TO: Frank Principe CMA
Fax #: 703 741-6257
FROM: Mike Lyden
RE: VCM Drawing - 141002

**STANDARD FOR
VINYL CHLORIDE MONOMER
TANK CAR
MANWAY COVER AND
PROTECTIVE HOUSING
ARRANGEMENT AND
EMERGENCY SAFETY KIT**

**FIGURE 2.1
STANDARD MANWAY COVER FOR 20" MANWAY
VCM TANK CARS**

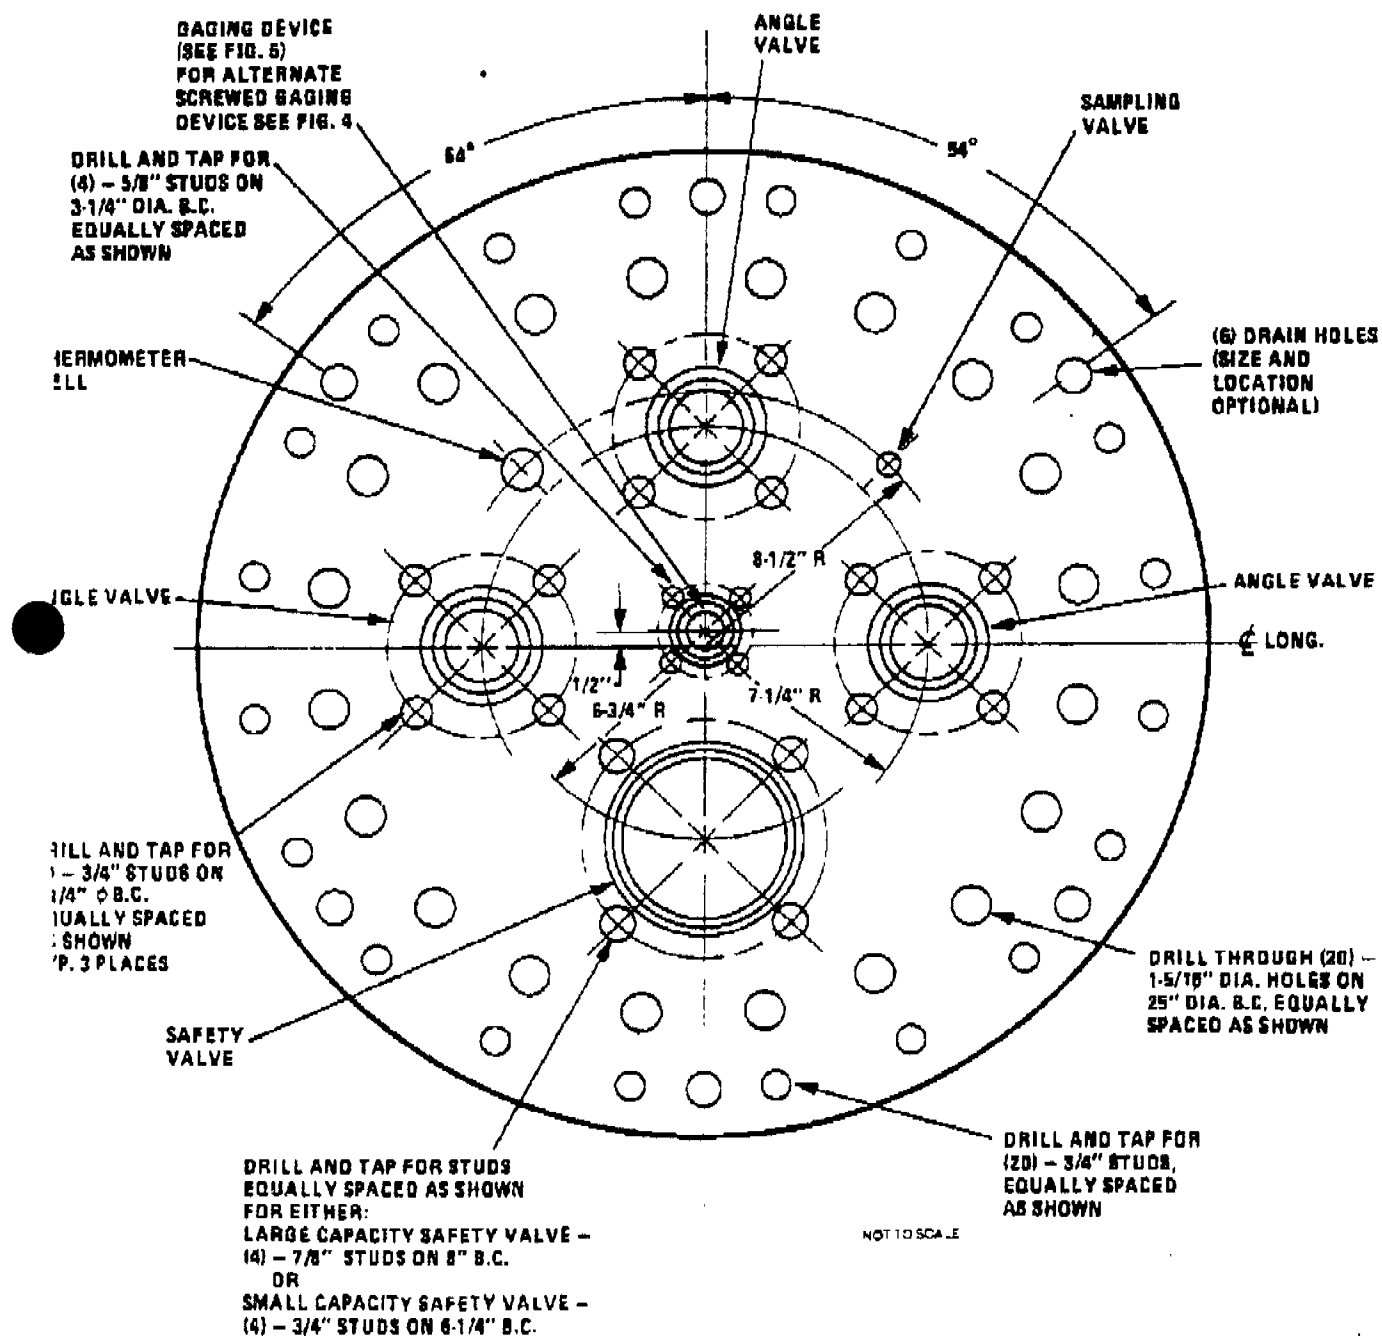
See ATTACHED for CGA Pamphlet P-10
Figures like this is what's needed.
I do believe it is an 20" NOT 18"
MANWAY cover
